**STAFF REPORT**  
**COMMUNITY DEVELOPMENT DEPARTMENT**

DATE: 7/9/2024  
TO: City Council  
FROM: Sonya Allen, Associate Planner  
208-884-5533  
SUBJECT: FP-2024-0010  
TM Creek No. 7  
PROPERTY LOCATION:  
153 S. Benchmark Way, in the northern  
½ of Section 14, T.3N., R.1W.

Final plat consisting of 10 building lots and one (1) common lot on 22.73-acres of land in the C-G zoning district for TM Creek No. 7.

B. Final Plat (dated: 4/18/24)

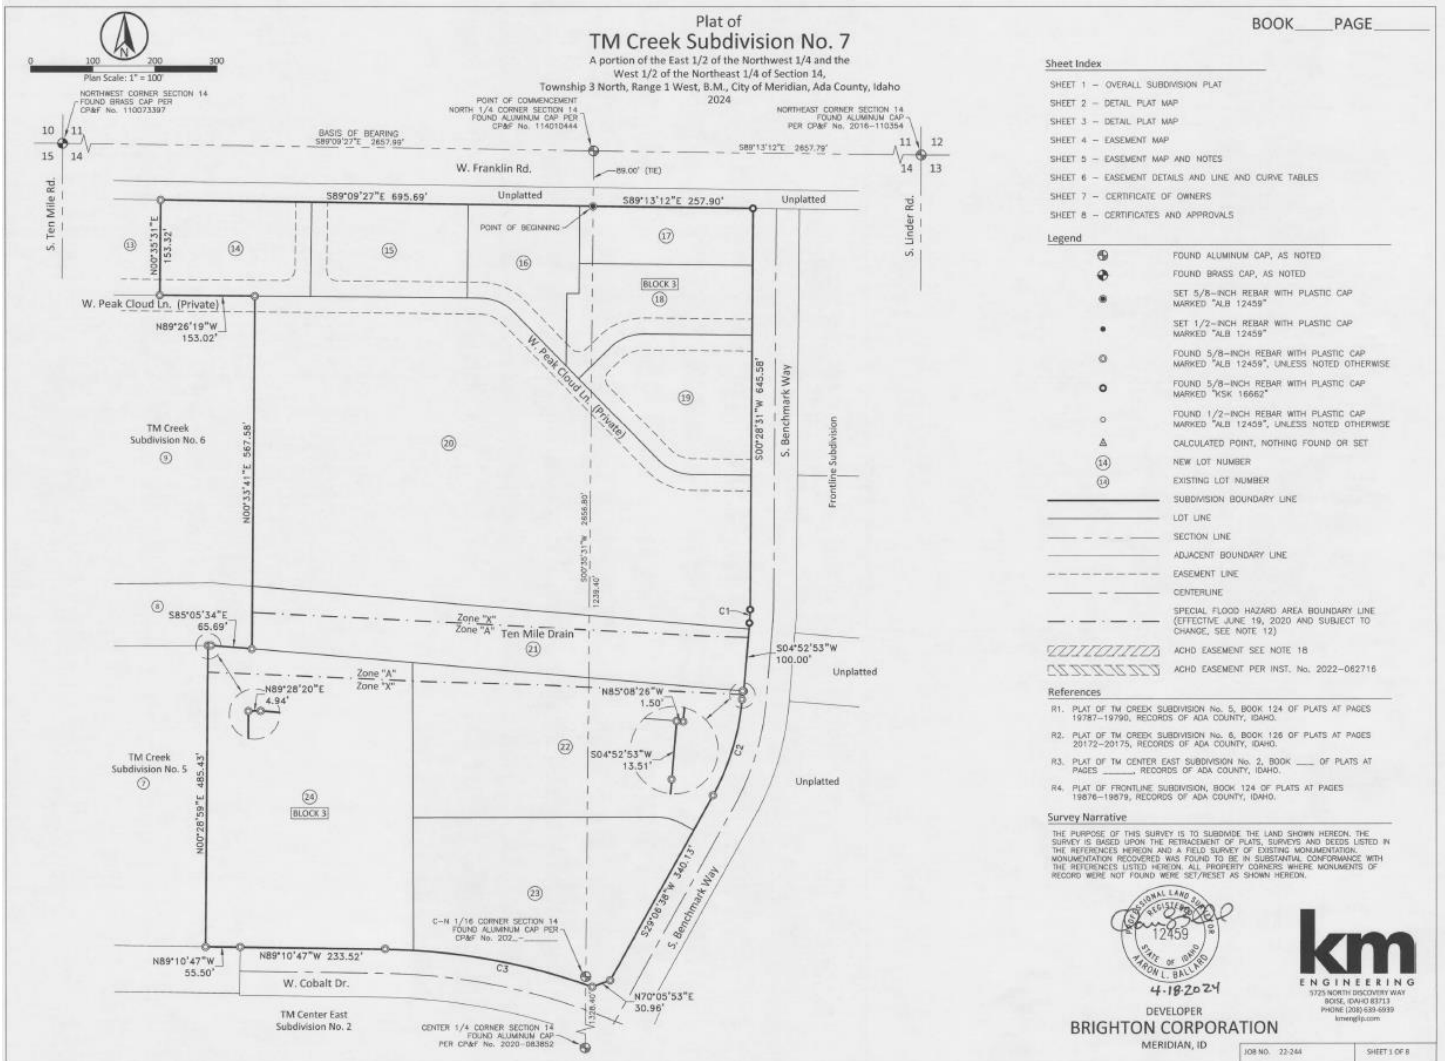
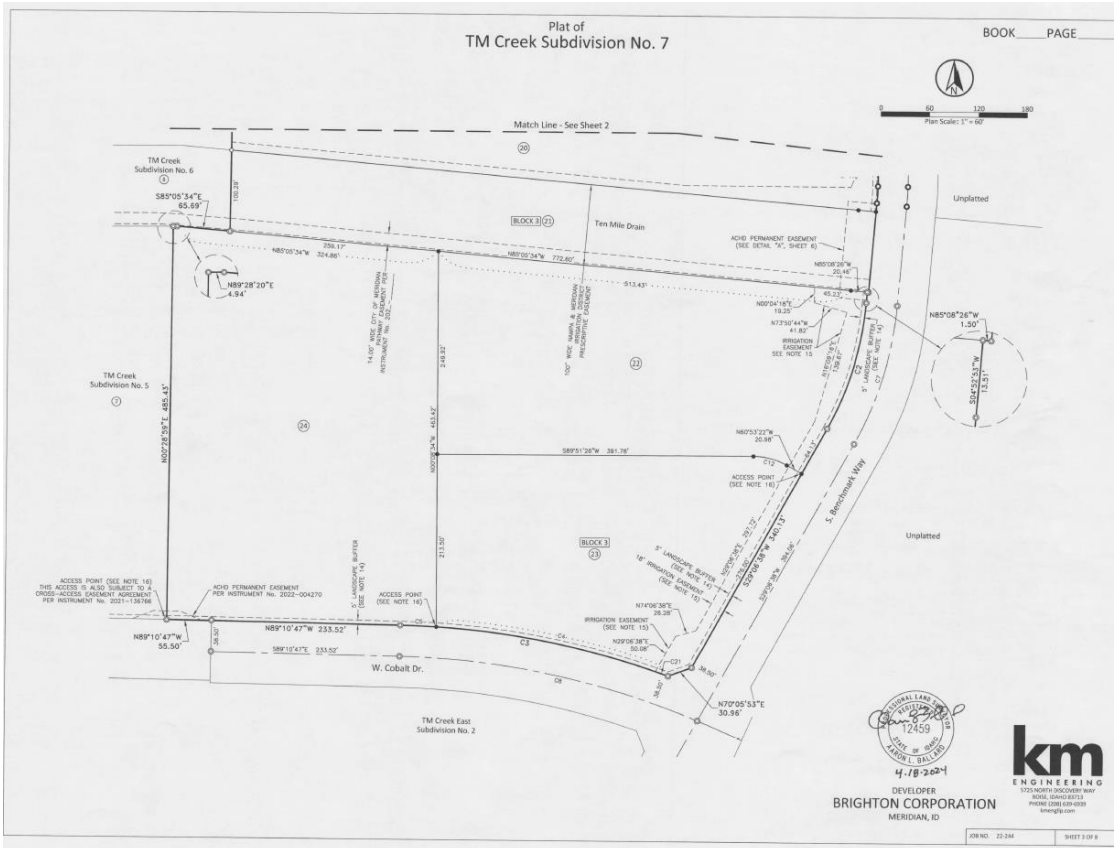
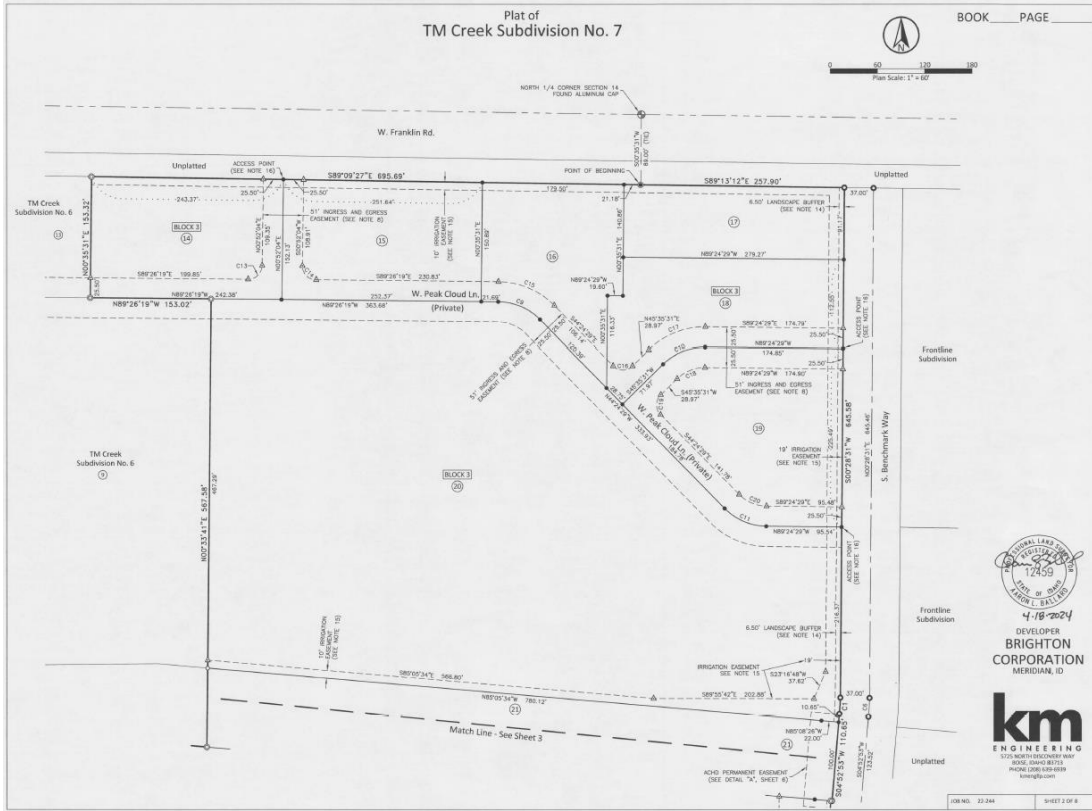
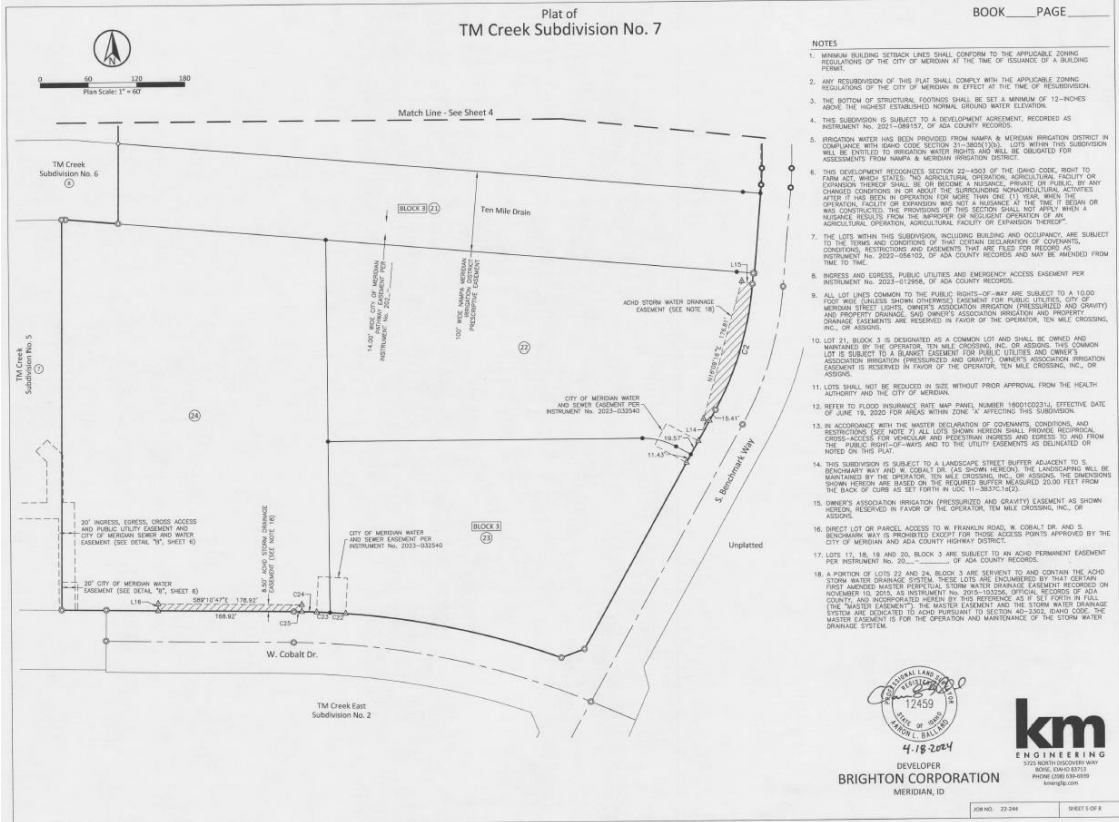
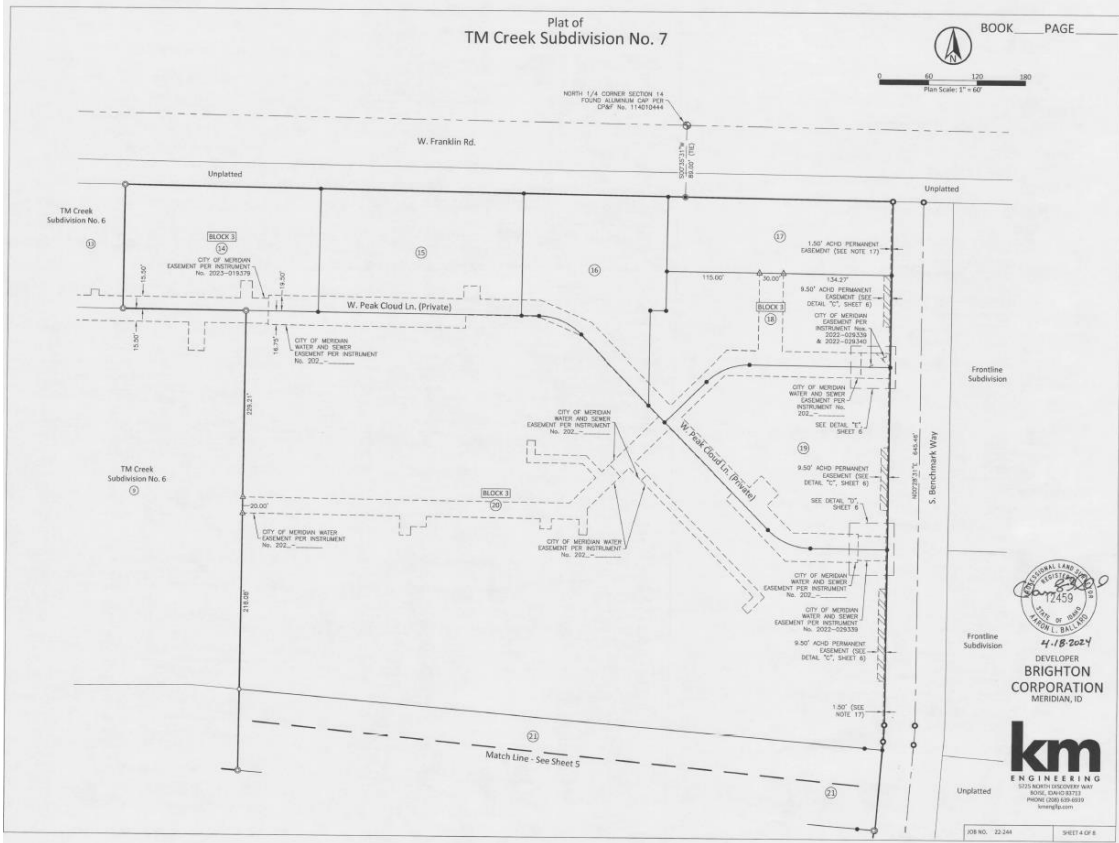
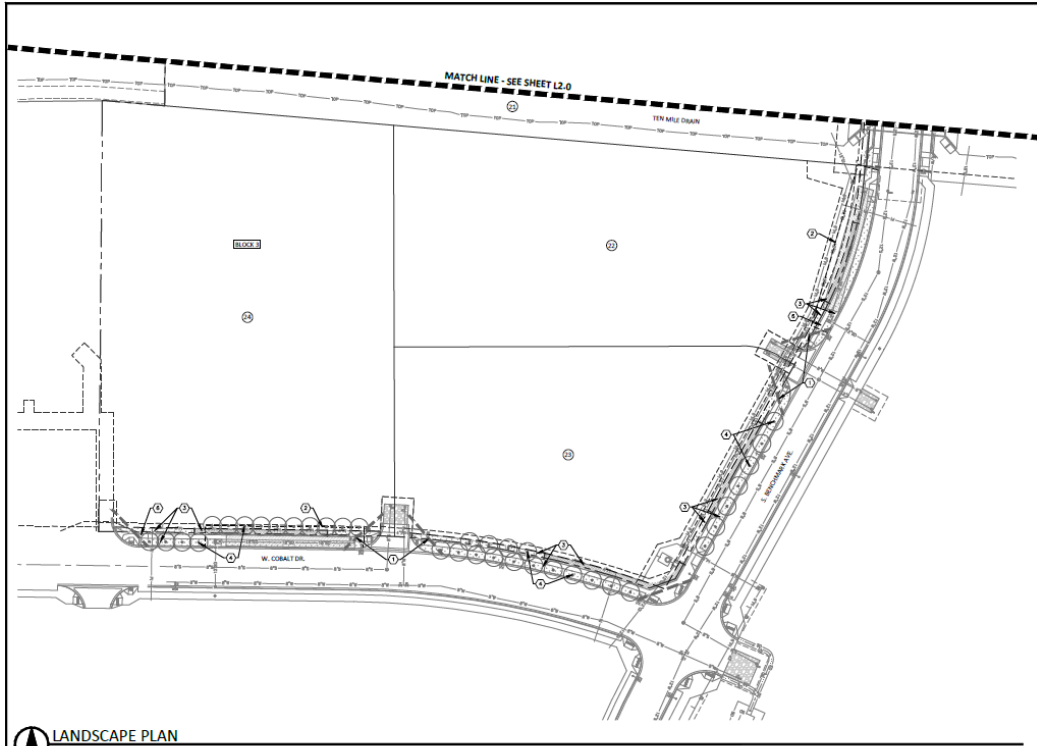
3. Prior to submittal for the City Engineer's signature, have the Certificate of Owners and the accompanying acknowledgement signed and notarized.
4. The final plat prepared by KM Engineering, stamped on 4/18/24 by Aaron L. Ballard, included in Exhibit B shall be revised as follows:

- a. Note #17: Include the recorded instrument number of the ACHD permanent easement.
  - b. A cross-access/ingress-egress easement shall be granted via a note on the plat or a separate recorded agreement between all non-residential lots in accord with UDC 11-3A-3A.2 and preliminary plat condition #2j.

- c. Include the recorded instrument number of the 14' wide City of Meridian pathway easement graphically depicted on the plat on Sheet 5.
  - d. Include the recorded instrument number of the City of Meridian water and sewer easement graphically depicted on the plat on Sheet 4.

- e. Include the recorded instrument number of the City of Meridian water easement graphically depicted on the plat on Sheet 4.
  - f. Include the number of the C-N 1/16 corner section 14 found aluminum cap per CP&F No. 202\_-\_\_\_\_\_ on Sheet 1.

- g. In the References notes on Sheet 1, include the book and page numbers of TM Center East Subdivision No. 2.
5. The landscape plan prepared by KM Engineering, dated 4/18/24 included in Exhibit C, shall be revised as follows:
